London Industrial Archaeology Society

**Regent's Wharf 10,12,14,16 and 18 All Saints Street, London N1
Objection to Planning Application No. P2016/4805/FUL**

Proposed elevation to canal

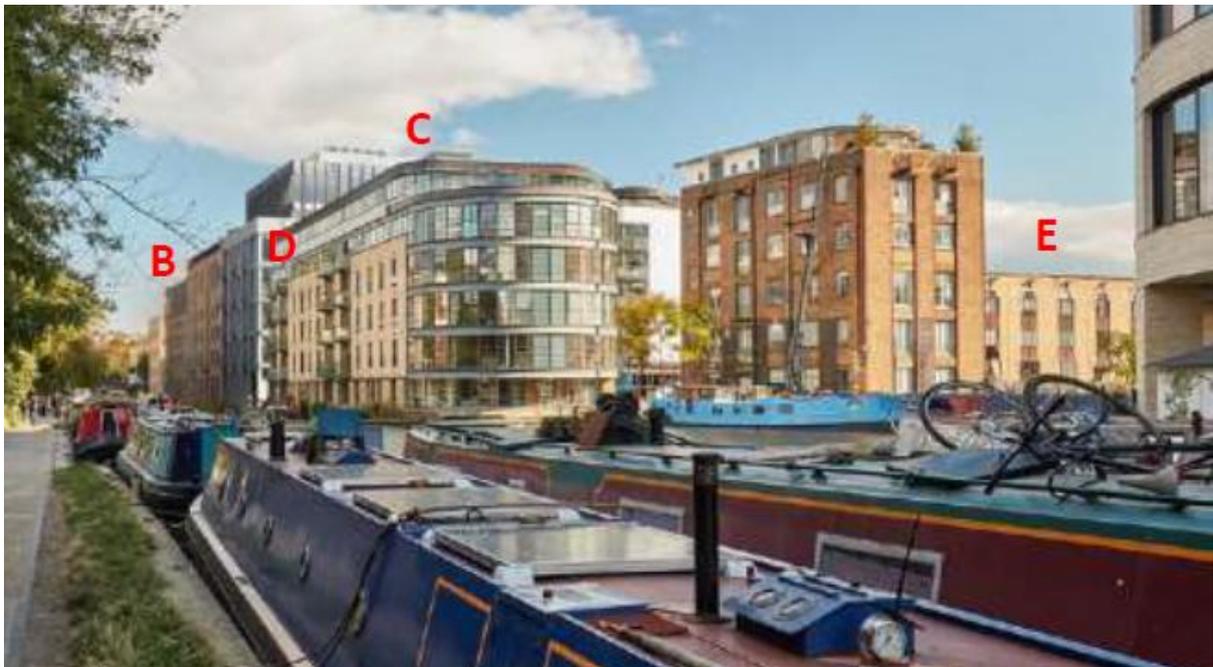
- Introduces giant dormers to the canal façade of Building 10c that are alien to the historic character.
- Destroys the distinctive original dormers and the roof structure.
- Grotesquely alters the traditional blind giant arcade of the canal facade of Building 12, introducing raised-up and out-of-proportion windows (and some clumsily cramped-up extra windows) in the new double top storey. These fight against the historic character.
- Replaces the probably original roof structure.
